# Needle Drop Ltd. (Extension)

16 November 2021

# Observations

Floor Load plan (1<sup>st</sup> floor)

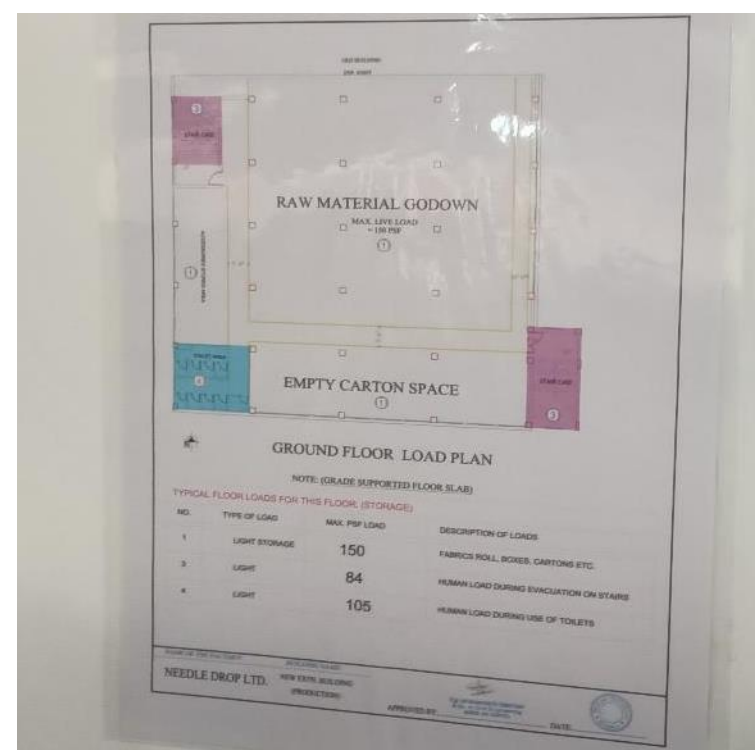
As per BNBC, the minimum floor live load for light storage is 6 kN/m<sup>2</sup> (125 psf). The storage in this building is designed for 5 kN/m<sup>2</sup> live loads. The building engineer is required to revise the storage live load limit based on BNBC requirement.

Item No.	Observation	Recommended Action Plan	Recommended Timeline
01	Prepared design report not comply with BNBC. (Main production building extension)	The building engineer to check the occupancies and update the floor live loading plan for the building based on BNBC loading requirements and capacity of building floor, column & foundations.	6-weeks
02	Prepared design report not comply with BNBC. (Main production building extension)	Revise the design report as per updated load plan.	6-weeks
03	Prepared design report not comply with BNBC. (Main production building extension)	Implement the floor loading plan (posting load plan, providing signage and maintaining loadings).	6-months
